REQUEST FOR COUNCIL ACTION

Restricted Development Conditional Use Permit #03-61 and

Substantial Land Alteration, by Larry Brown and L.B. Electric. The applicant is proposing to develop approximately 3 acres of land with a Trade Shop use. Additionally, the applicant is requesting approval for a Substantial Land Alteration permit to modify the grades by 10 feet or more near the southern portion of the site. The property is located along the south side of TH

Restricted Development Conditional Use Permit #03-61 by Larry Brown

GRADING AND EROSION CONTROL PLAN

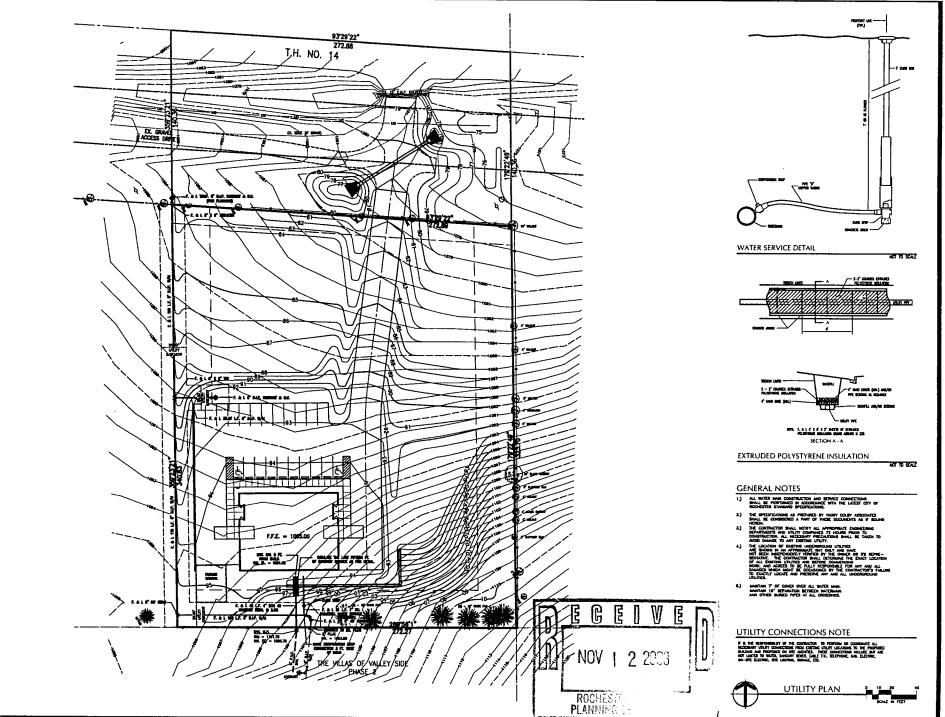
- 1. Grading & Drainage Plan approval is required prior to development. A Storm Water Management fee will apply for participation in the City's Storm Water Management Plan (SWMP).

- 2. Surety in a form and amount determined by the City Engineer is required for restoration of the proposed Substantial Land Alteration being proposed for this project.

L.B. ELECTRIC ROCHESTER, MIN UTILITY PLAN

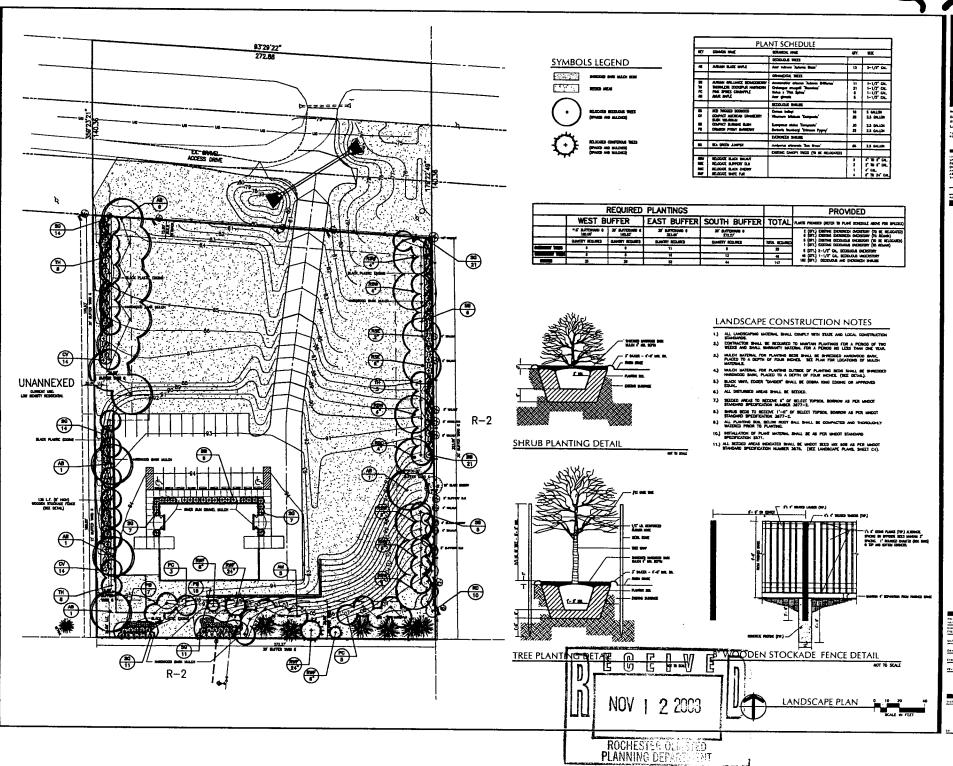
- 3. Prior to final CUP approval, the Owner shall execute a Development Agreement with the City to in part address the Owner's future obligations for the extension of watermain to the abutting easterly property owner, across the north line of this Property, as required by RPU Water.

- 6. Dedication of a utility easement to the west line of this Property is required to accommodate the future connection of the abutting Property to municipal sewer & water. In addition, execution of a 20 ft utility easement will be required to the north line of the Property.

- 7. Execution of a City-Owner Contract is required prior to construction of the proposed watermain and hydrant needed for this Property.

I just received a modified plan from YCA that addresses all the issues I had on this development, so as far as RPU-Water is concerned this SDP is now approved. I will send you a copy of the approved plan.
